BURTON-PATE INDUSTRIAL PARK SUBDIVISION, **RESUBDIVISION OF LOTS 1 AND 2**

APPLICATION NUMBER 1 DATE January 3, 2013
 APPLICANT Burton-Pate Industrial Park Subdivision, Resubdivision of Lots 1 and 2
 REQUEST Subdivision

DETAIL SITE PLAN

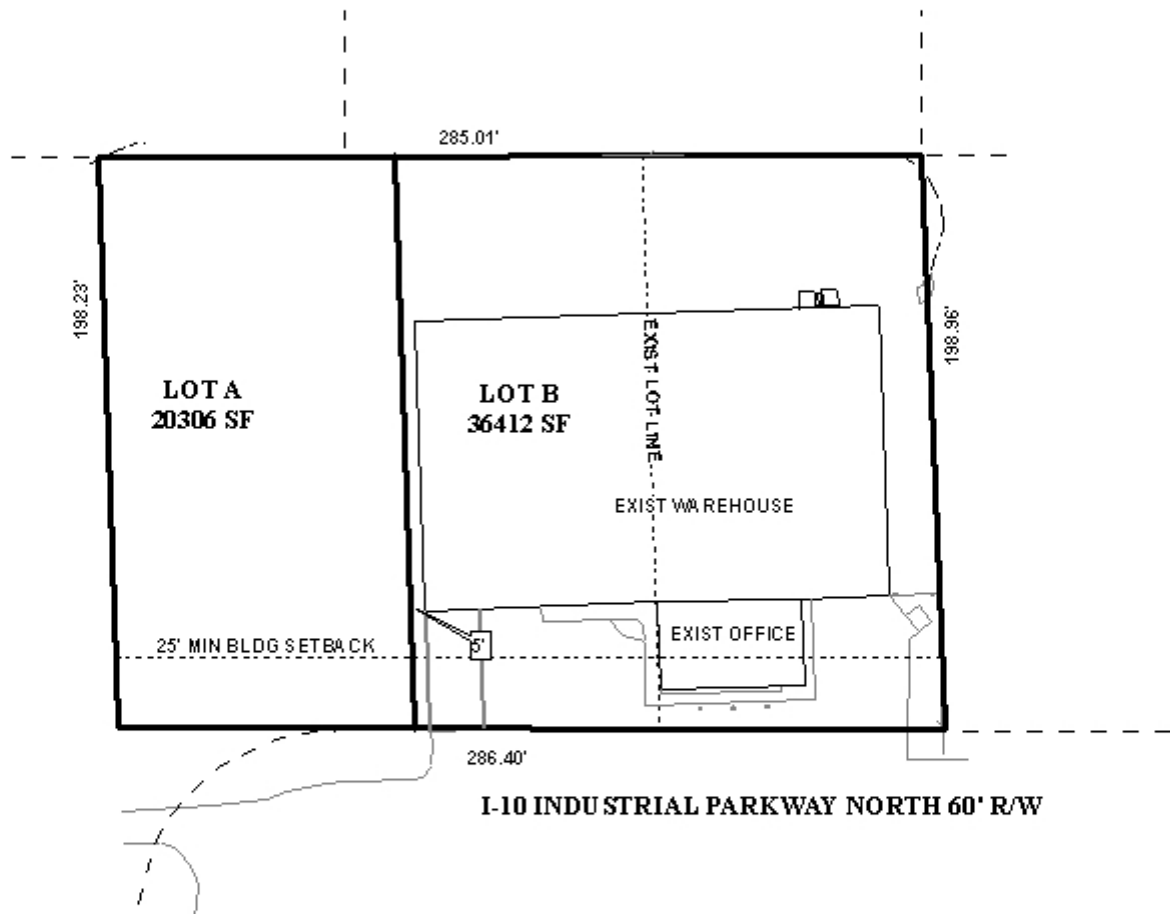
The lot sizes are labeled, and the proposed lots would exceed the minimum size requirements of Section V.D.2. of the Subdivision Regulations. The lot sizes should be retained in square feet and acres on the Final Plat, as on the preliminary plat, if approved.

The site fronts onto I-10 Industrial Parkway North, a minor street with no curb and gutter. The preliminary plat illustrates a compliant 60' right-of-way making no dedications necessary.

The 25-foot minimum building setback line, required in Section V.D.9., is illustrated and labeled along all frontages on the preliminary plat. If approved, the 25-foot building setback line should be retained on the Final Plat. There is a portion of an existing office located in the required front setback, however because the encroachment is existing, and no new construction is proposed at that time, it is considered a legal non-conforming structure. It should be noted however that any future construction must comply with setback requirements.

As a means of access management, a note should be placed on the Final Plat, if approved, stating that Lot A is limited to one curb cut to I-10 Industrial Parkway North, and Lot B is limited to existing curb cuts to I-10 Industrial Parkway North, with the size, location and design to be approved by Traffic Engineering and conform to AASHTO standards. It should also be noted that the preliminary plat incorrectly labels the street as "I-10 Industriall Parkway North". If approved, the street name should be revised to be spelled correctly.

- 1) illustration of the 25' minimum building setback line;
- 2) labeling of the lot size in square feet and acres;
- 3) revision of the street name to correctly read "I-10 Industrial Parkway North";

- 4) placement of a note that future development of the site will require full compliance with all municipal codes and ordinances;
- 5) compliance with Engineering comments (*The following comments should be addressed prior to review, acceptance and signature by the City Engineer: 1. Provide all of the required information on the Final Plat (i.e. signature blocks, signatures, certification statements, legal description, required notes). 2. A signature for the Traffic Engineering Department shall be placed on the Final Plat. 3. Add a note to the Plat stating that storm water detention will be required for any unapproved development (since 1984) and any future addition(s) and/or land disturbing activity in accordance with the Storm Water Management and Flood Control Ordinance (Mobile City Code, Chapter 17, Ordinance #65-007 & #65-045). 4. Provide a drainage easement to contain any existing drainage ditch/swale. Size and location to be approved by the City Engineer. 5. Show approximate centerline of existing drainage ditch located near the NE corner. 6. The existing dumpster shall contain its own storm runoff, collect it in a central drain, and transport it to the Sanitary Sewer system. 7. Add a note to the plat that any proposed dumpster(s) shall contain its own storm runoff, collect it in a central drain, and transport it to the Sanitary Sewer system.*);

- 6) compliance with Fire Department comments (*All projects within the City of Mobile Fire Jurisdiction must comply with the requirements of the 2009 International Fire Code, as adopted by the City of Mobile.*);
- 7) placement of a note on the Final Plat stating Lot A is limited to one curb cut to I-10 Industrial Parkway North, and Lot B is limited to existing curb cuts to I-10 Industrial Parkway North, with the size, location and design to be approved by Traffic Engineering and conform to AASHTO standards; and
- 8) placement of a note on the Final Plat stating that approval of all applicable Federal, state and local agencies is required for endangered, threatened or otherwise protected species, if any, prior to the issuance of any permits or land disturbance activities.
